**Addendum No. 2**

**FRIENDSHIP FOREST WILDLIFE SANCTUARY**

**PARK RENOVATION**

## Double Leg Pedestal (DLP)

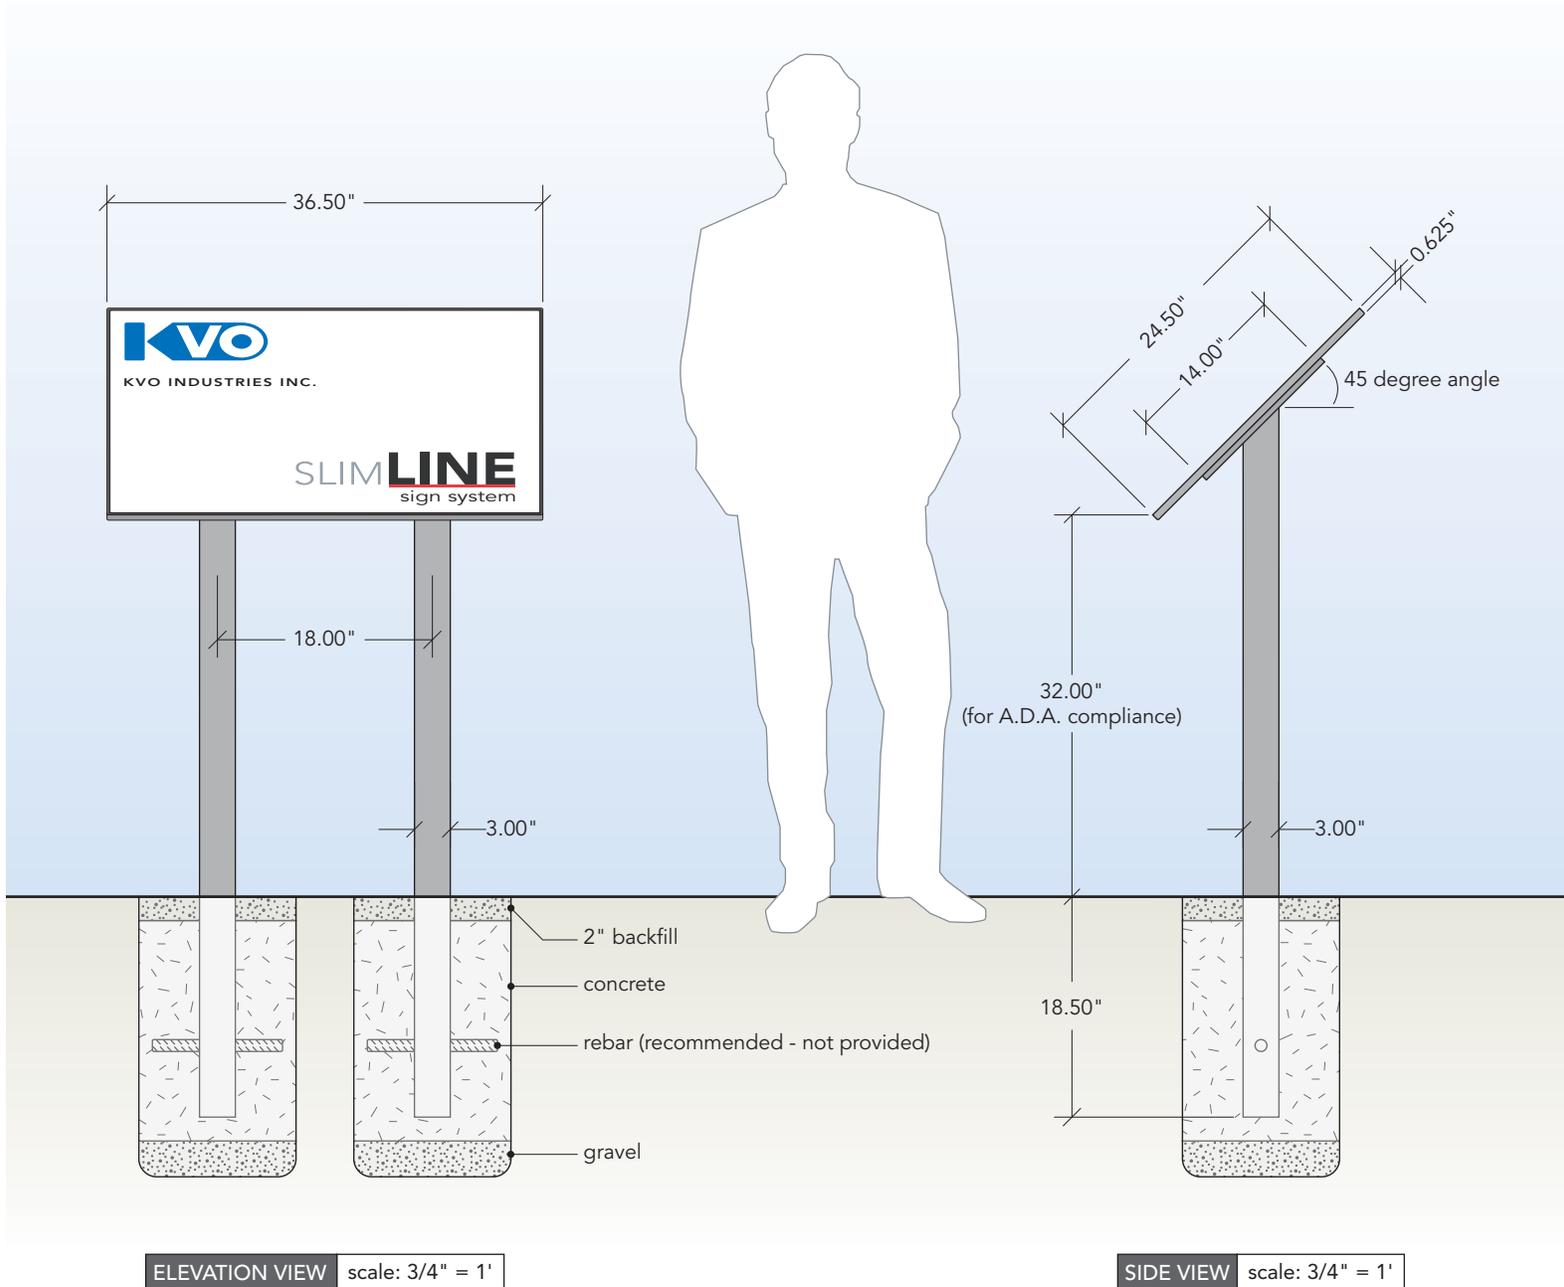
On bid form, under section "Site Elements" on page 18, item number "48", it calls out for "Interpretive Signage with Frame/Stands" (QTY.10). I found (QTY.2) details #4, labeled "Message Sign Detail" on plan page "A3.1" is that the correct detail for the "Interpretive Signage with Frame/Stands"? If yes, where are they located on the plans and how many of each type of "Interpretive Signage with Frame/Stands" there on the plans?

**Please refer to the attached cut sheet. Only the pedestals/frames are to be purchased (QTY – 10). No “wording” or other interpretative language/details are to be included as a component of the pedestals**
